REV. A

AS5185™

FITTING, ELBOW, 90°,
PIPE TO HOSE

ISSUED 2000-01 REAFFIRMED 2004-07 REVISED 2021-09

FIGURE 1 - FITTING, ELBOW, 90°

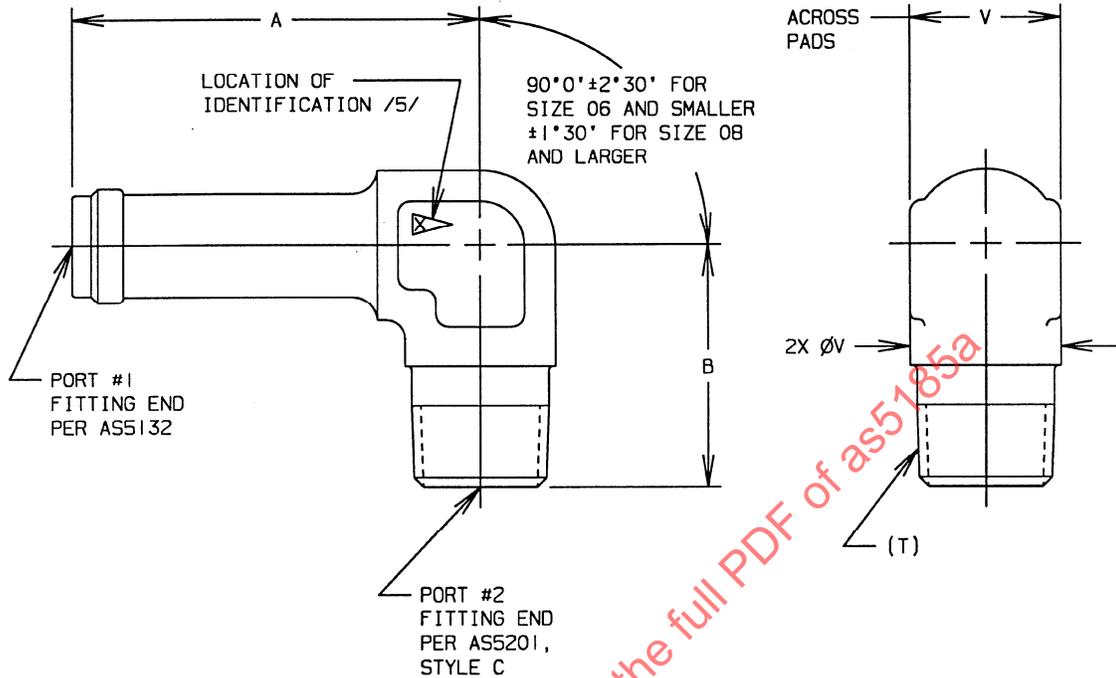
REVISE EXISTING NOTE, CENTER BODY DIMENSION TO REFER TO AS1376 TABLE 9 IN LIEU OF TABLE 1. REVISION INDICATOR AND DISPOSITION OF EXISTING INVENTORY NOTE ADDED. OPTIONAL MATERIAL ADDED TO ALUMINUM FINISH. GENERAL UPDATE INCORPORATED.
